UNITED STATES PATENT AND TRADEMARK OFFICE

APPLICATION NO.	FILING DATE	FIRST NAMED INVENTOR	ATTORNEY DOCKET NO.	CONFIRMATION NO.
09/670,661	09/27/2000	Lawrence W. Miller	104041-1	7892

Office Action Summary

Fig.A

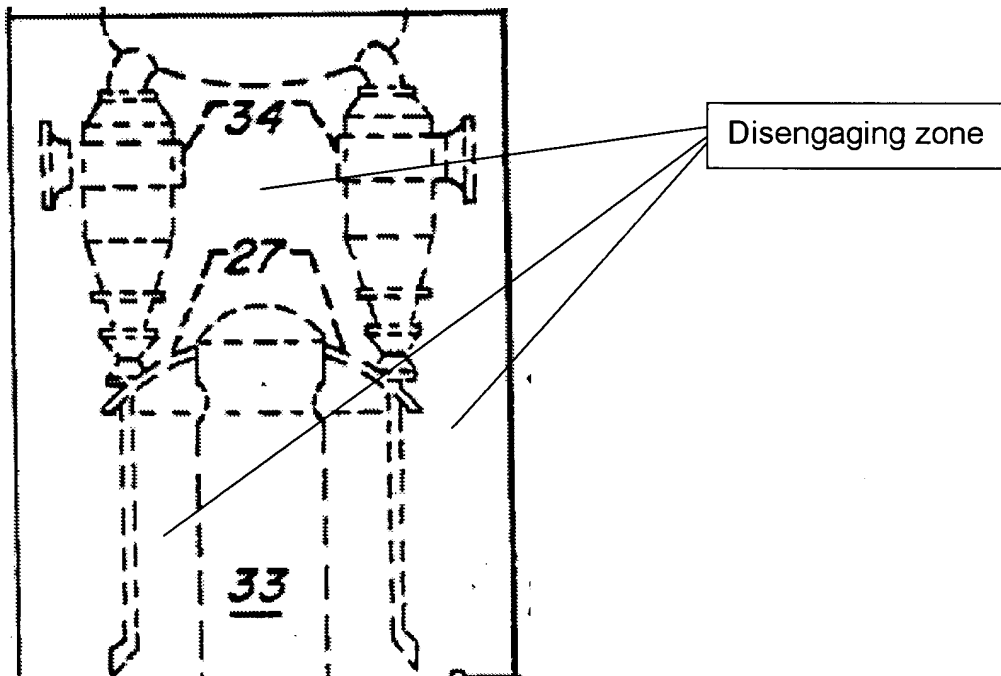
- A **reaction vessel** (Fig. 2, entire image) defining a **disengaging zone** (Fig. A),

a **lower subadjacent reaction zone** (also a dense phase zone) (Fig.2, item 25), a **product outlet** (Fig. 2, item 36) for withdrawing the product stream from the disengaging zone, and a **feed inlet** (interface between Fig.2, items 22 and 24) communicating with the lower reaction zone; (Per the applied prior art, Examiner notes that in Cabrera et al, item 22 is identified as a mixing riser, but functions to transport feed into lower reaction zone (dense phase zone).

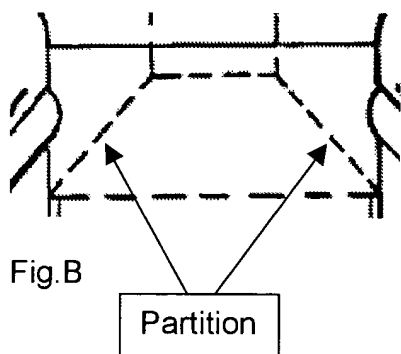
- a **partition** sealingly disposed about an intermediate portion of the reaction vessel to segregate the reaction zone from the disengaging zone (Fig.B)

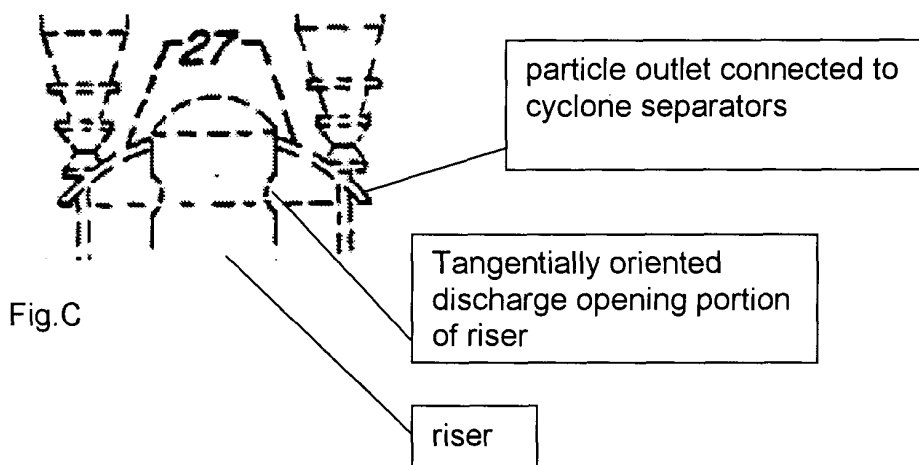
- a **riser** (Fig. 2, item 33) extending vertically within the reaction vessel from the reaction zone into a central section of the disengaging zone, in fluid communication with the reaction zone, for conducting the product stream and fluidized catalyst particles and defining a discharge opening within said disengaging zone for discharging the product stream and fluidized catalyst particles, said discharge opening being tangentially oriented for imparting a tangential velocity to the product stream and fluidized catalyst particles (see Fig.C);

- a separation vessel (Fig.2, item 27) disposed over said riser in the disengaging zone and surrounding said discharge opening to separate gaseous products from fluidized catalyst particles, said separation vessel having a lower portion defining a particle outlet for discharging fluidized catalyst particles and said separation vessel defining a gas recovery outlet for withdrawing gaseous fluids from the separation vessel; (Per the relied upon prior art, Examiner interprets "riser outlet 27" as a separation vessel since said "riser outlet" separates gas and catalyst C13/L44-46. Additionally, since the riser outlet passes catalyst particles into cyclone separators, a

particle outlet is necessarily present for without it there can be no physical interface with said cyclone separators. Fig.C illustrates the relied upon prior art's particle outlet:
